1	Airflow Balancing	8-17-2016
Revisions	Date

**PARTIAL ATTIC FLOOR PLAN**

**Renovate Space for Rehab Therapy Clinics in B211**

**M102**

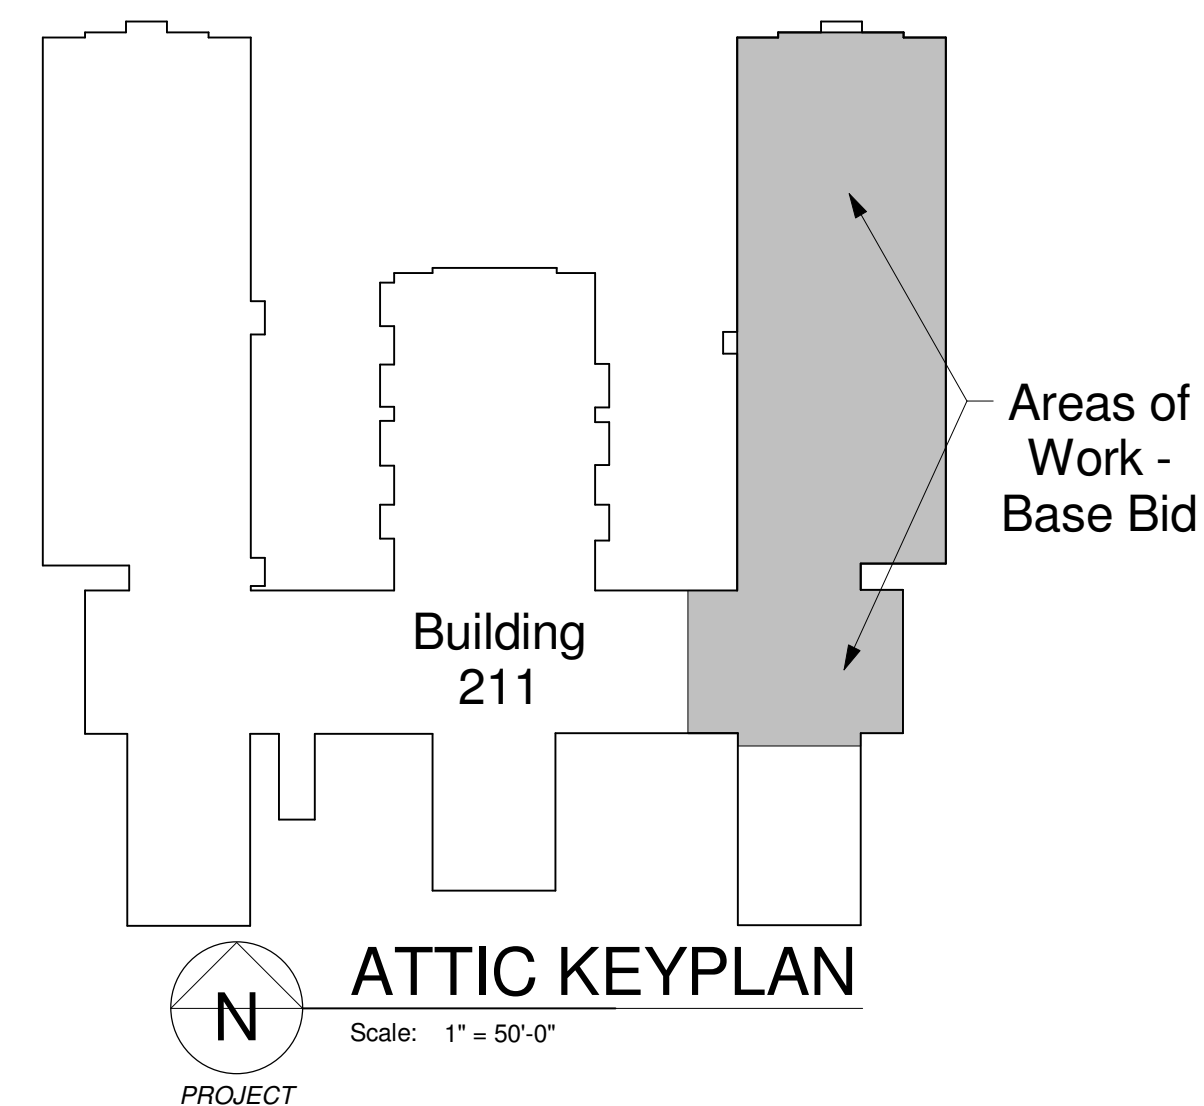
- PLAN NOTES**
- 1 RE-BALANCE EXISTING SUPPLY FAN 211-SF2 TO 23,055 CFM. REPLACE SHEAVES AS REQUIRED.
- 2 RE-BALANCE EXISTING RETURN FAN 211-RF2 TO 16,965 CFM. REPLACE SHEAVES AS REQUIRED.

- 3 RE-BALANCE EXISTING EXHAUST FAN 211-EF3 TO 4,935 CFM. REPLACE SHEAVES AS REQUIRED.
- 4 EXISTING DDC CONTROL PANEL ASSOCIATED WITH 211-AHU3 TO REMAIN. INTEGRATE NEW BASEMENT AIR TERMINAL UNITS INTO DDC SYSTEM THROUGH THIS PANEL. INTERCEPT LON BUS IN BASEMENT - REFER TO SHEET M101.

- 6 RE-BALANCE EXISTING DUCT BRANCH TO EXISTING CFM INDICATED. COORDINATE LOCATION OF EXISTING DUCT BRANCHES AND BALANCE DAMPERS WITH COR.
- 7 RE-PROGRAM POSITION OF MODULATING CONTROL DAMPERS TO RE-BALANCE MINIMUM OUTSIDE AIR OF EXISTING UNIT TO 6,085 CFM.

- 8 APPROXIMATE LOCATION OF 211-AHU3 AND ASSOCIATED DDC CONTROL PANEL. RE-PROGRAM RETURN FAN VFD TO MAINTAIN OFFSET OF 1,200 CFM FROM SUPPLY CFM.
- 9 APPROXIMATE LOCATION OF 211-AHU2 DDC PANEL, AND RETURN FAN VFD. REPROGRAM RETURN FAN VFD TO MAINTAIN OFFSET OF 6,085 CFM FROM SUPPLY CFM.
